STATE OF MAINE  
DEPARTMENT OF TRANSPORTATION  
16 STATE HOUSE STATION  
AUGUSTA, MAINE 04333-0016

December 8, 2022  
Subject: Acadia Gateway  
State WIN: 017163.03  
Location: **Trenton**  
**Amendment No. 1**

In the Bid documents make the following changes

SHEET NUMBER  
**C102**

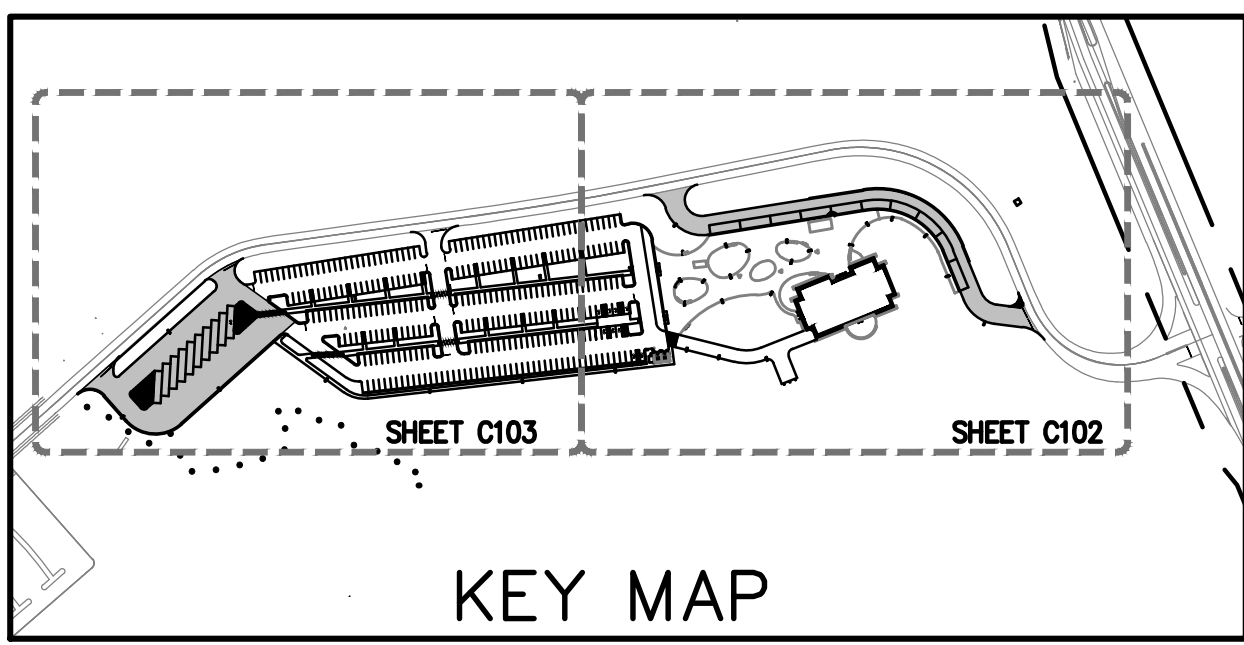
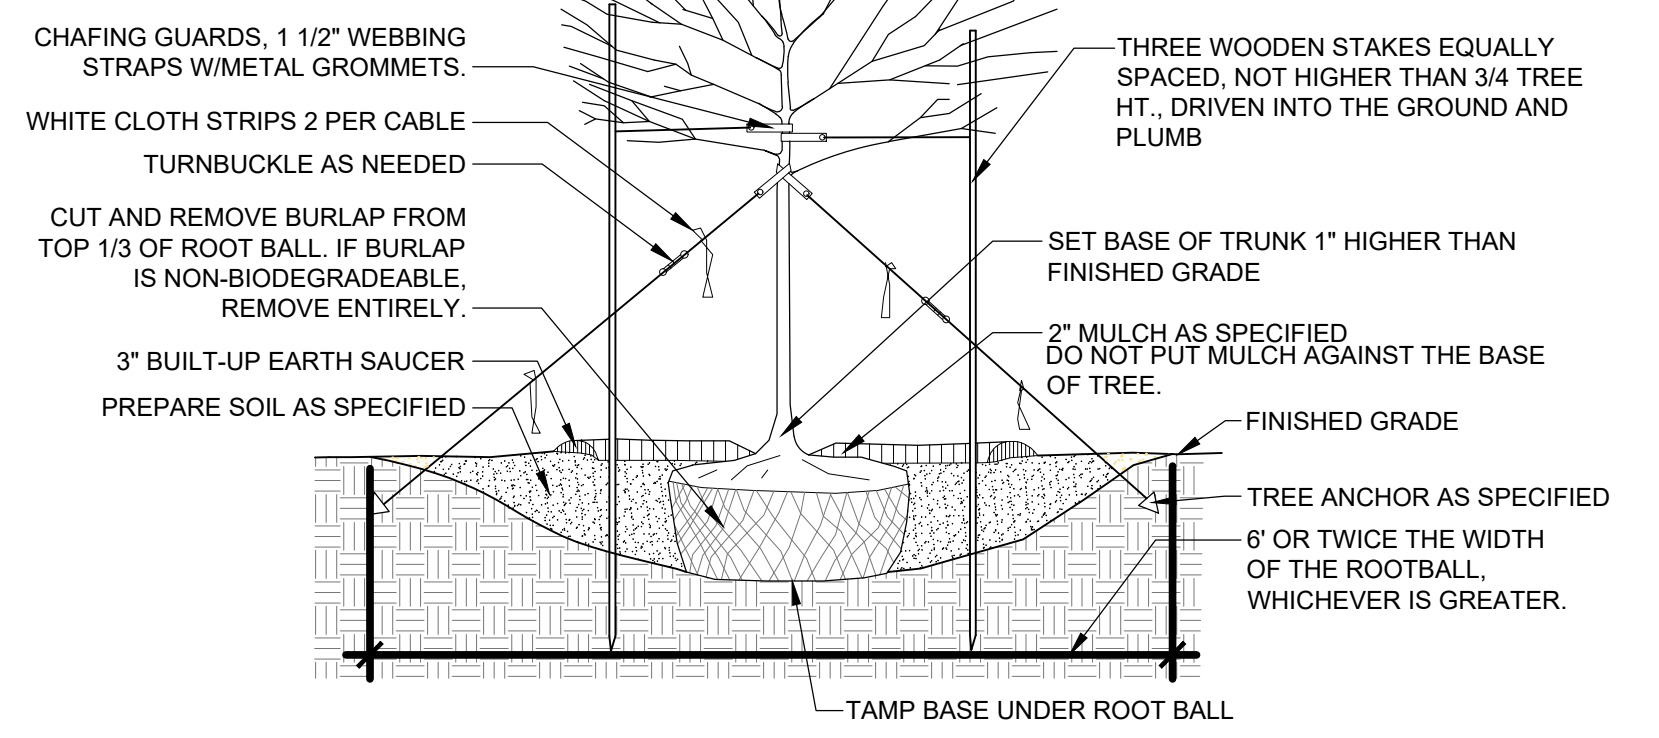
**Remove** page C102 titled CIVIL SITE PLAN – EAST and **Replace** with the attached CIVIL SITE PLAN – EAST

**Question:** Sheet C102 note states "curbing is included in lump sum bid area". There are pay items for the curbing listed. Please clarify.

AMENDMENT #1 REVISIONS:  
 - REMOVED CURBING NOTE

**Response:** This was an extraneous note on C102 and has been removed. Updated C102 included in Amendment #1.

SHEET NUMBER  
 L206

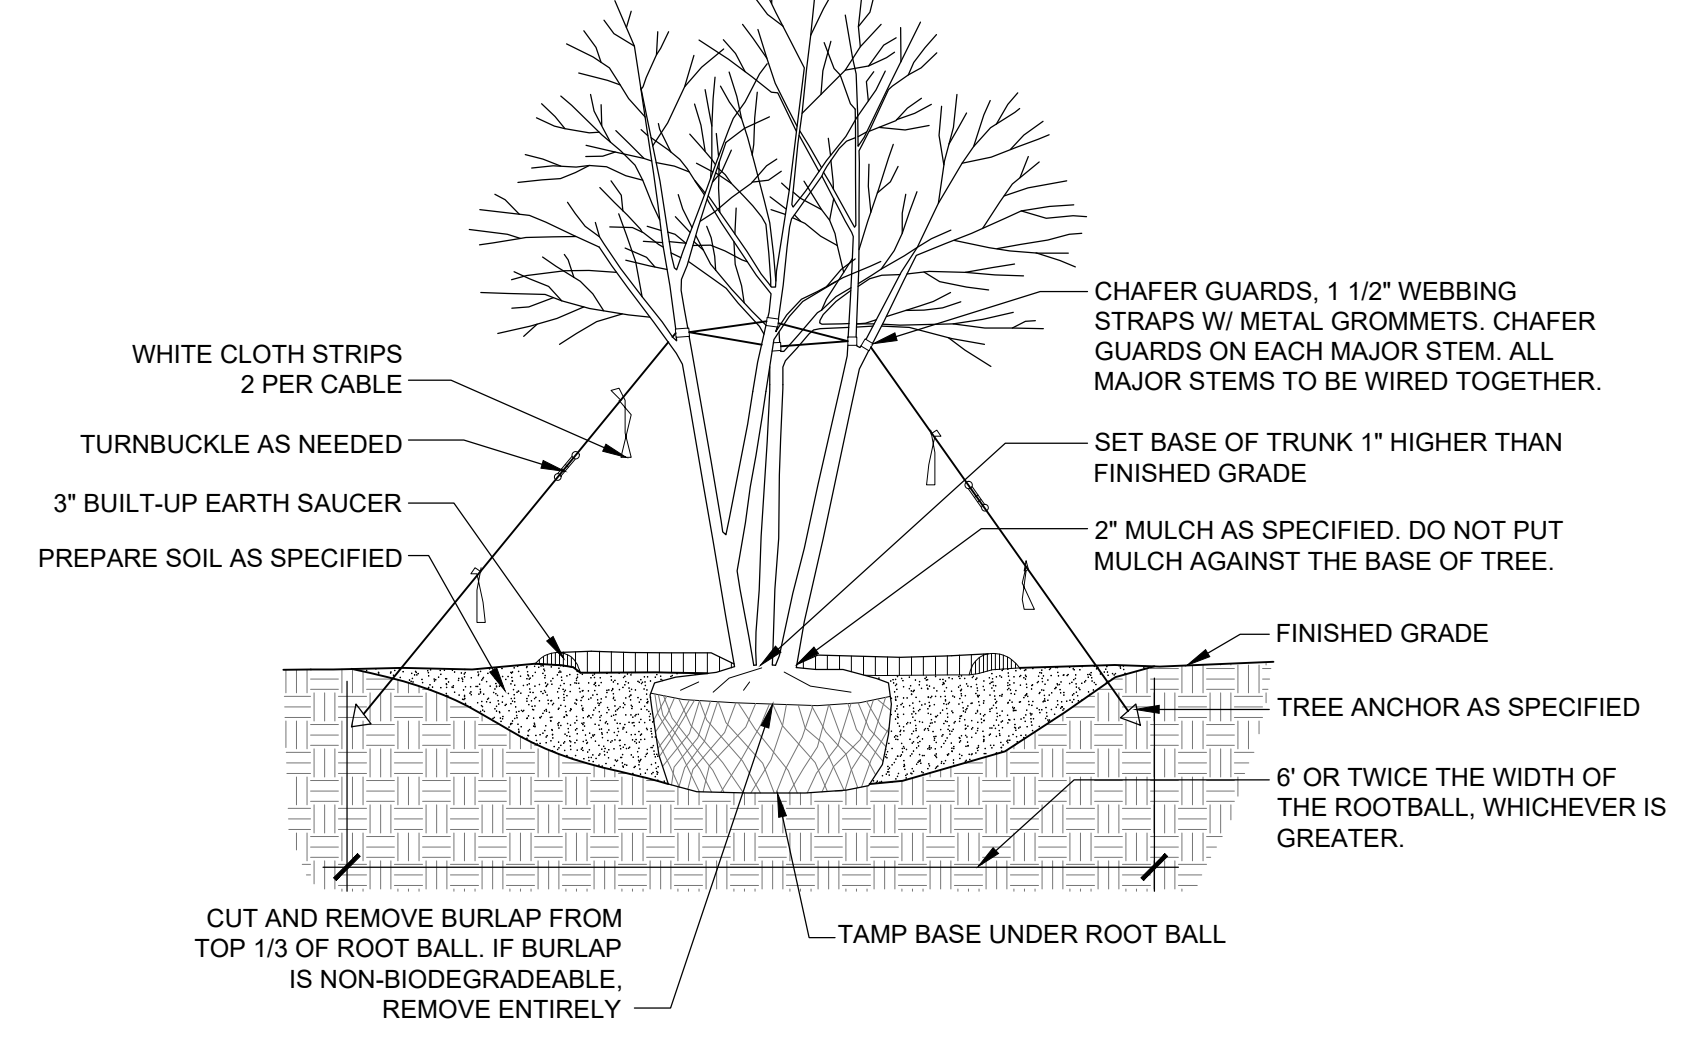
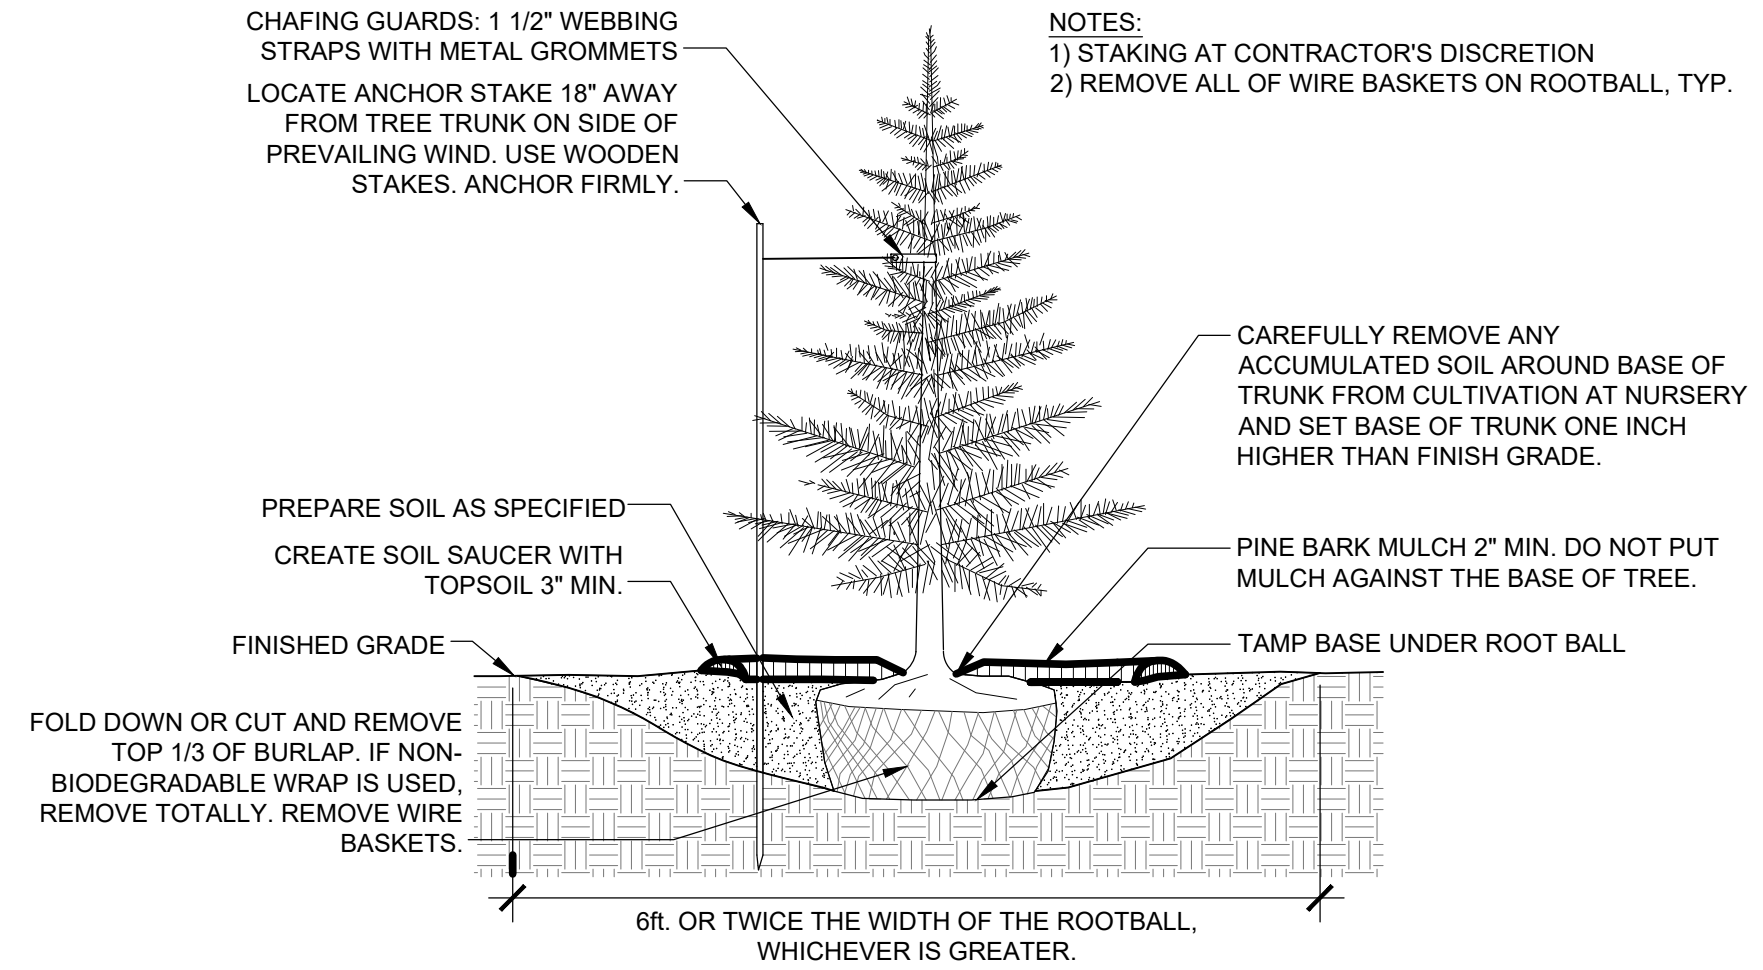
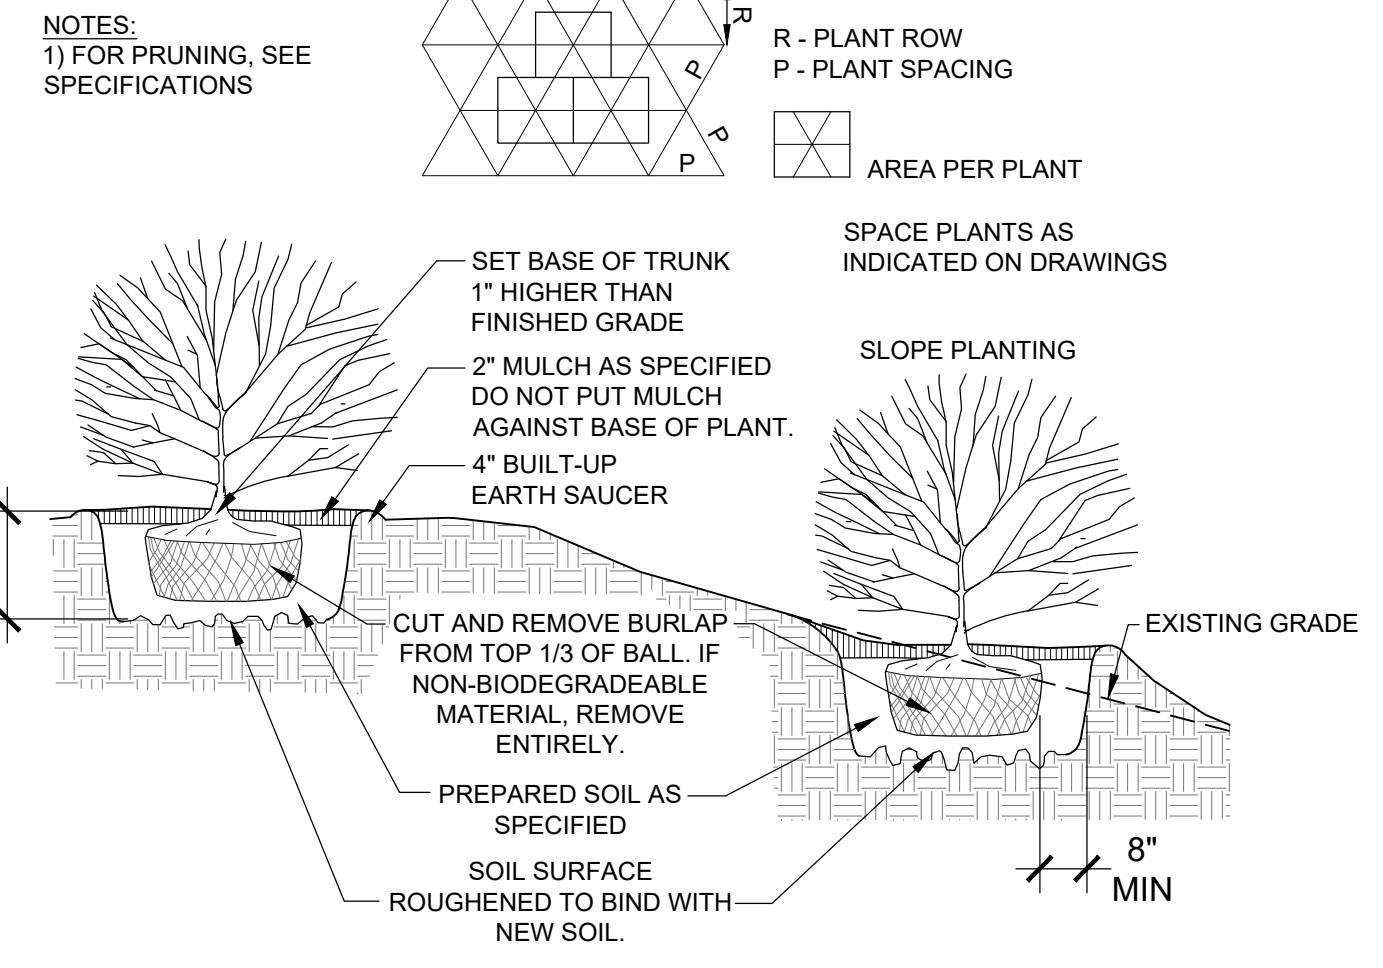
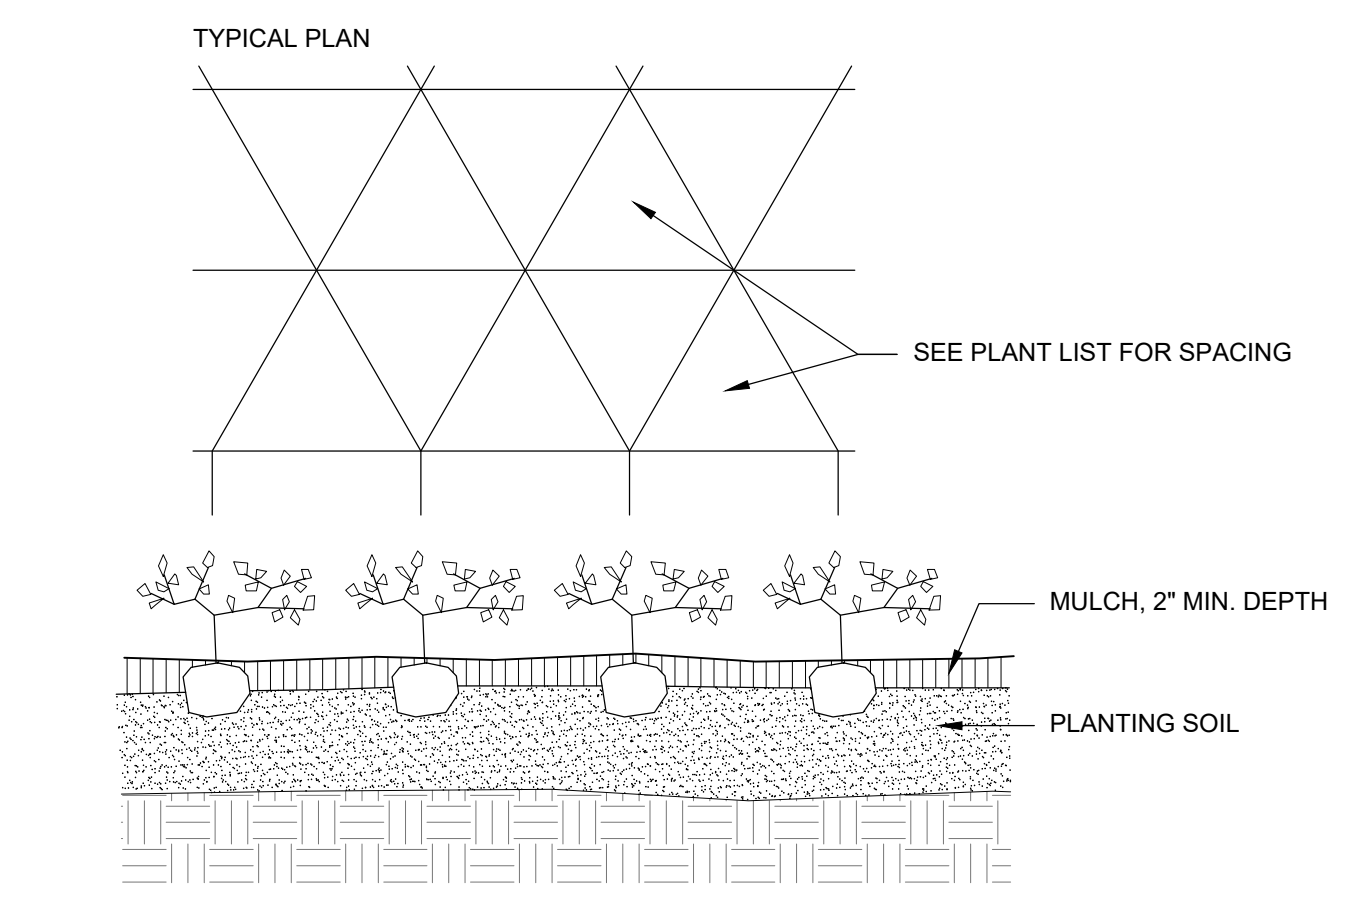
**Remove** page L206 PLANTING NOTED DETAILS & SCHEDULE, and **Replace** with the attached PLANTING NOTES, DETAILS & SCHEDULE

**Question:** Please review the landscaping Bid Schedule of items and the Plant list in spec. section 32 93 00. There are bid items that are not on the Plant list and there are items on the plant list that are not listed as Bid Items. Please clarify.

Amendment #2  
 Revised pay items numbers, corrected quantities and sizes

**Response:** In Bid Book Volume#4 Under SECTION 32 93 00 PLANTING, PART 4 – COMPENSATION delete part 4.03 PAYMENT ITEMS pages 32 93 00 -15 and 32 93 00 -16. See the Landscape Plans, Specifications, and the revised Master Plant Schedule on SHEET (L206) for plant locations, sizes, descriptions and pay items numbers.
